**AEROSPACE STANDARD**  
BOLT, MACHINE, DOUBLE HEX, EXT WASHER  
HEAD, CLOSE TOL. SHANK, UNS N07718, 185 KSI MIN,  
.2500-28UNJF-3A (STRESS RUPTURE RESISTANT)

**AS3418™**  
SHEET 1 OF 3

**REV. B**

ISSUED 1995-12 REVISED 2017-06 REAFFIRMED 2022-04

FIGURE 1 - BOLT

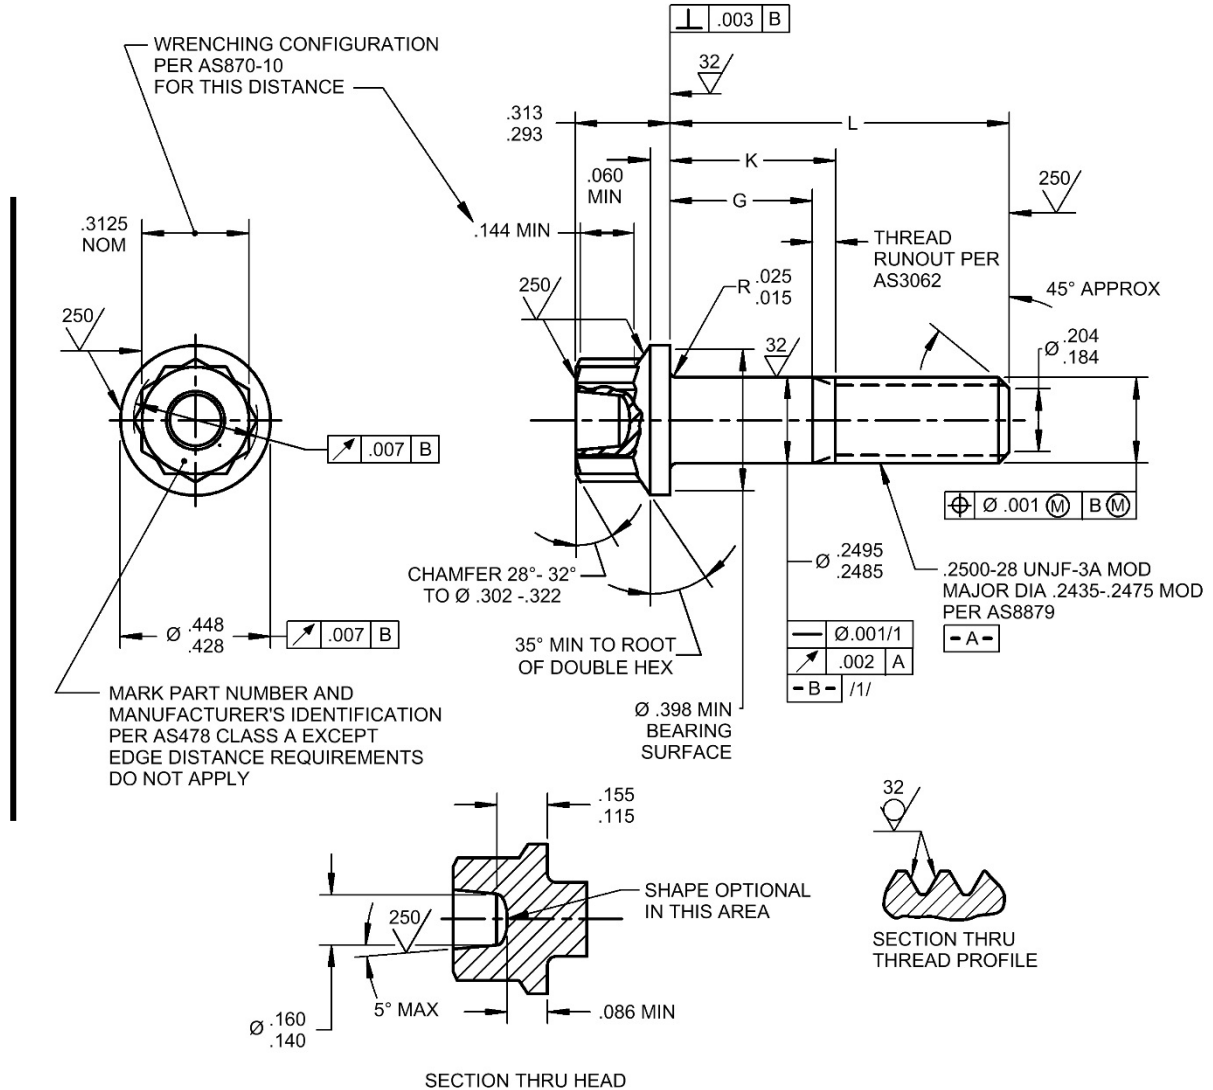
DELETE RADIUS AT TRANSITION OF WRENCH FLATS AND BASE FLANGE, UPDATE FEATURE CONTROL FRAME FOR STRAIGHTNESS, ADD EDGE DISTANCE EXCEPTION FOR HEAD MARKING, ADD SURFACE TEXTURE REQUIREMENTS FOR HEAD, WRENCH FLATS AND BOLT END, ADD NEW NOTE FOR DISPOSITION OF EXISTING INVENTORY, UPDATE FPI REFERENCE AND ADD STANDARD SENSITIVITY REQUIREMENT, FIGURE 1 RE-DRAWN, AND GENERAL EDITORIAL CHANGES.
